**IMPERIAL ROAD DESIGN MANUAL**  
**REVISIONS July 2010**

### ***Separation - Shoulder and Ditch Street***

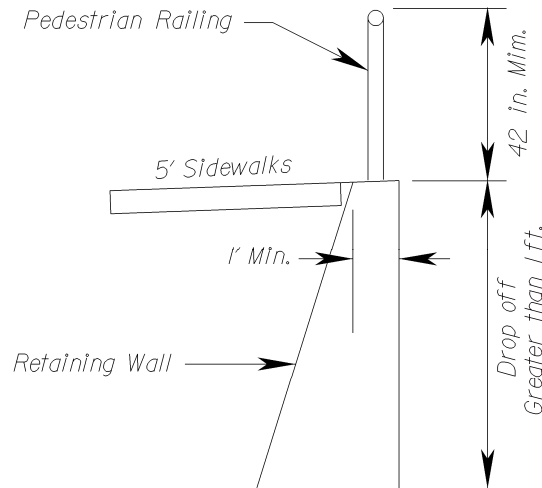
*Sidewalks constructed along a shoulder and ditch section shall be placed behind the ditch in a manner that will be compatible with the roadway if the roadway is converted to a curb and gutter section. (Note: Placement of sidewalk within the shoulder area is not permitted.)*

*\* No railing is required if a 1' min. graded area is provided at the back of sidewalk when the slope is 2:1 or flatter, unless adjacent to a parallel water hazard 2' deep or other obvious hazard. If a railing is required the graded area behind the sidewalk shall be increased by 1' to accommodate the railing. Contact the Location and Design Standards and Special Design Section for details.*

*Railing is required when sidewalk is constructed adjacent to a vertical drop-off greater than 1'. However, gripping rail is required only when the grade of the sidewalk is 5% or greater. Contact the Location and Design Standards and Special Design Section for details.*
